August 8, 1994

CUMBERLAND FOSSIL PLANT (CUF) - INSPECTION OF WASTE DISPOSAL AREAS

CUMBERLAND FOSSIL PLANT - INSPECTION OF THE WASTE DISPOSAL AREAS

Figure 1. Excellent vegetative cover on interior slope of dike in area no. 2.
Note small trees growing on interior.

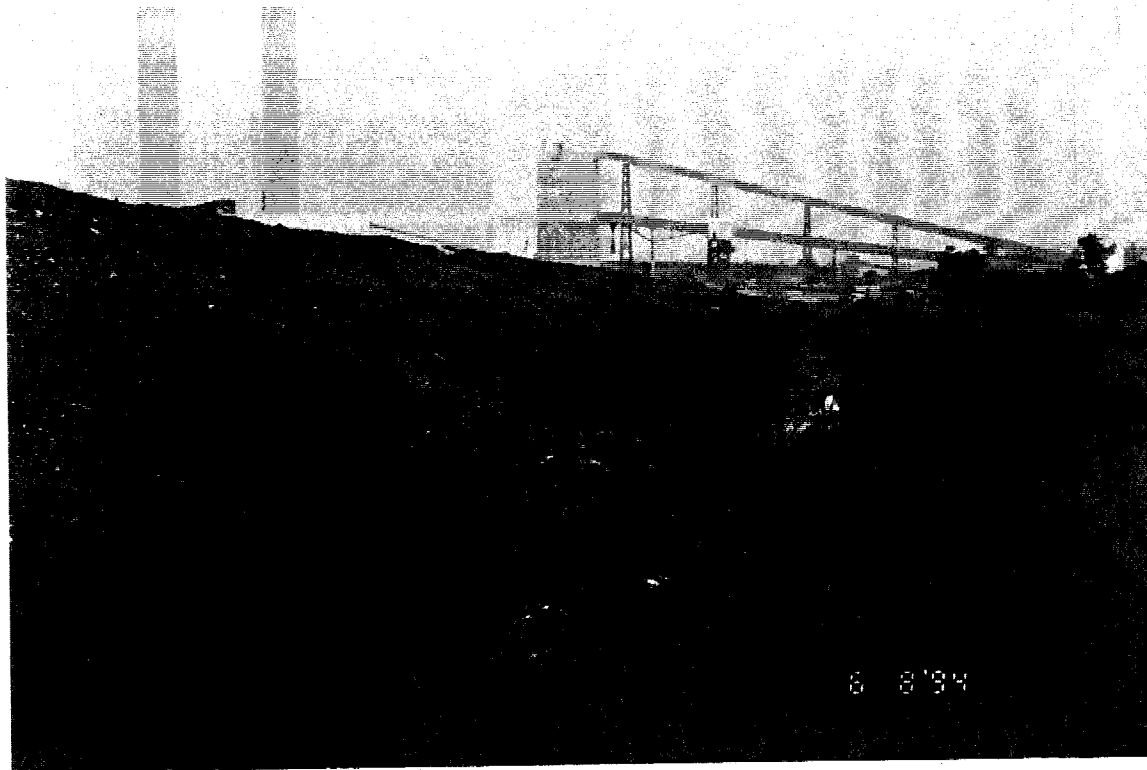
- 3.1.1 A new dike for the gypsum disposal area is being constructed in the eastern end of this area.
- 3.1.2 The pond level is currently being raised to elevation 384 to compensate for water storage that is being lost due to present and future construction.
- 3.1.3 A few small trees are beginning to grow on the interior dike slope in this area. These trees should be removed with their root structures to prevent future seepage or failures.
- 3.1.4 The areas of seepage along the Wells Creek Channel were not visible due to high water in the channel. Inspection revealed no signs of structural instability anywhere along the dike.
- 3.1.5 Vegetative cover was good on the dikes of this area (Figure 1).

- 6.1 All trees along the interior slopes of the dikes should be removed by pulling with a chain to remove their root systems. (Reference 3.1.3)
- 6.2 Remove the trees located on the slope above the outlet discharge pipes by pulling them. The vegetation should be kept cut here so that stability of the slope above the pipes can be monitored.
- 6.3 Continue to monitor the seepage areas, especially since the water level behind the dike is being raised (Reference 3.1.2). Report any problems to Site Engineering.

Figure 2. Ditch separating starter dike for wet gypsum stack from perimeter dike in area no. 1

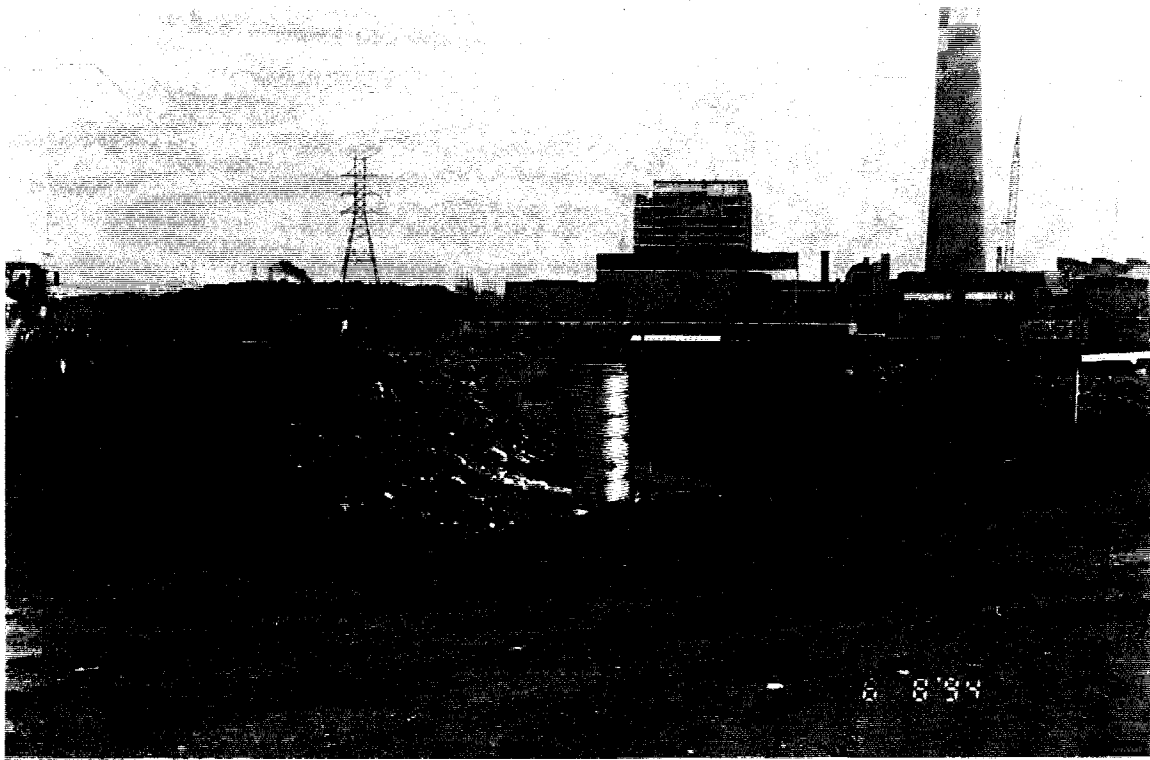
The dredge pond is full and has no water standing in it. A wet gypsum waste storage facility is currently being prepared in this area. A starter dike is being constructed to elevation 410 along the interior of and parallel to the northern, southern, and eastern perimeter dikes (Figure 2). The western boundary of the wet gypsum area will be defined by a starter dike which is currently being constructed to elevation 410 parallel to the eastern side of the 161 kV transmission line in area no. 2 (Figure 3).

Figure 5. Spillway outlet pipe. Buildup of ash material is evident.

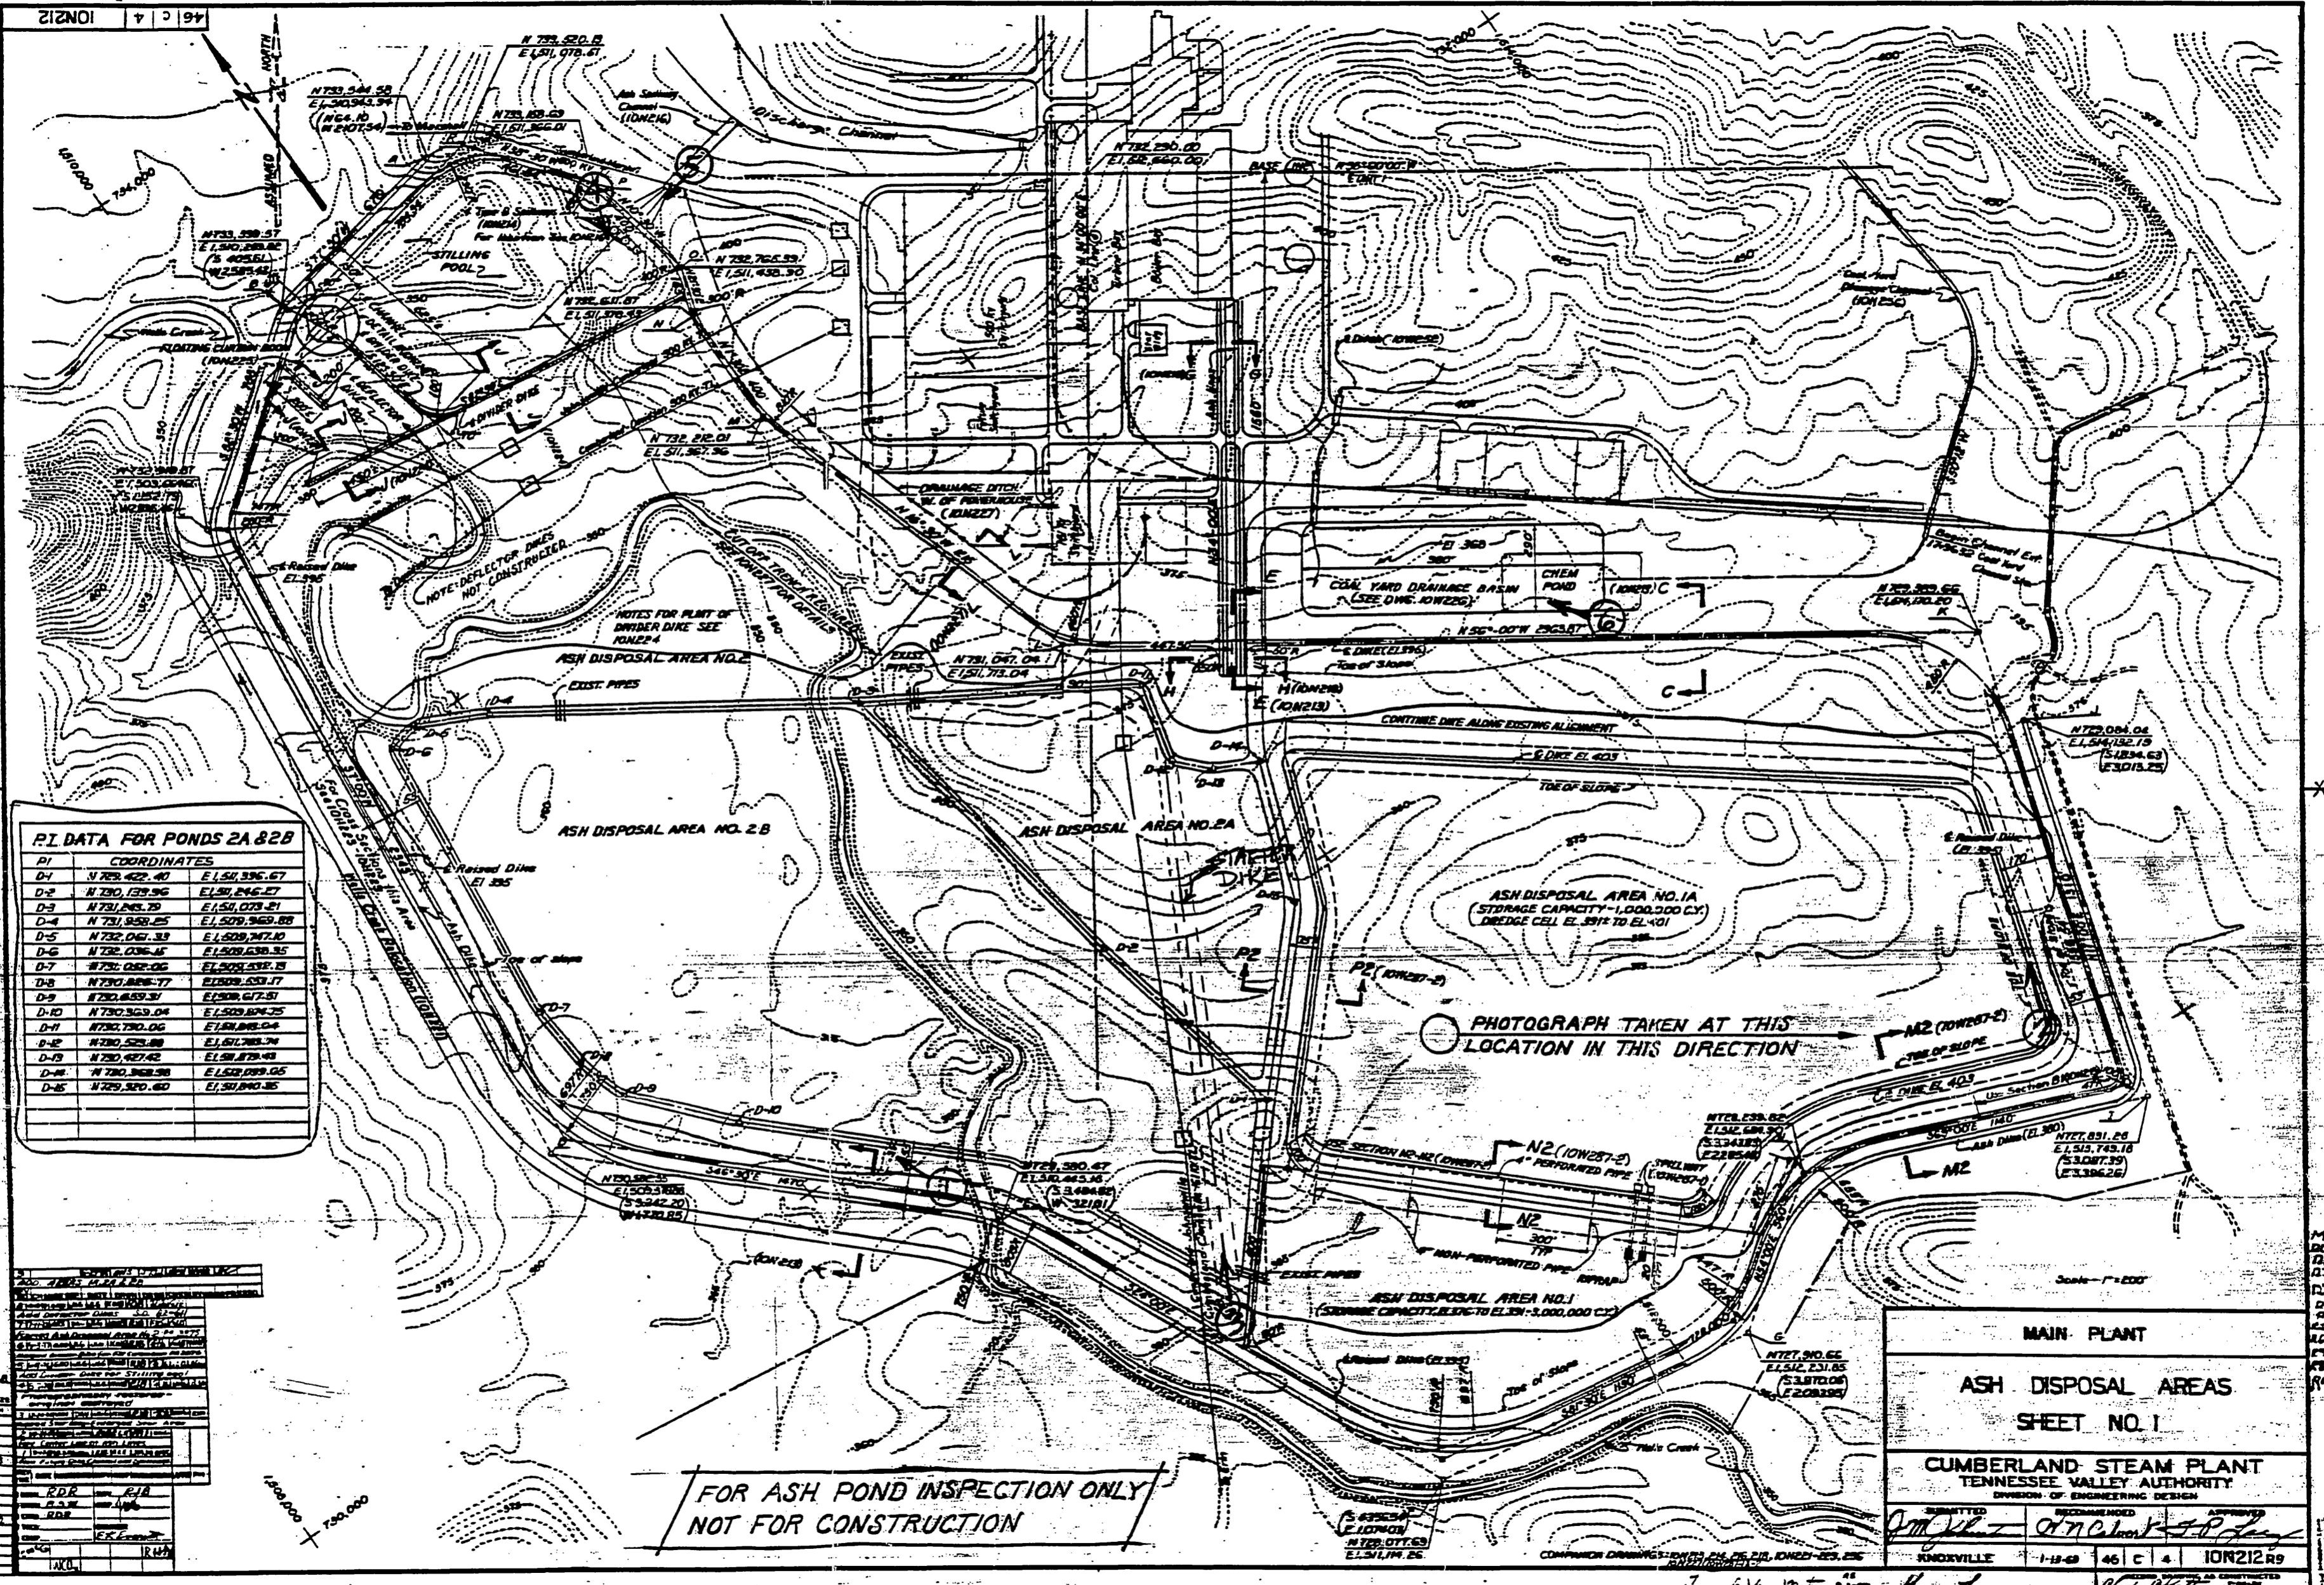
- 3.3.1 All spillways and skimmers appear to be in good condition. A small amount of floating ash was present in the stilling pool, but it was judged as insignificant.
- 3.3.2 The four spillways located on the northeastern corner of area no. 2 had just been raised to increase the pool elevation, so no flow was passing through them at the time of inspection. The spillways were not inspected because the access walkways were not installed due to the recent modifications (Figure 4). The spillway outlet pipes contained a fair amount of ash build-up around their inner walls. This buildup should be monitored and removed if spillway operation becomes hindered (Figure 5).
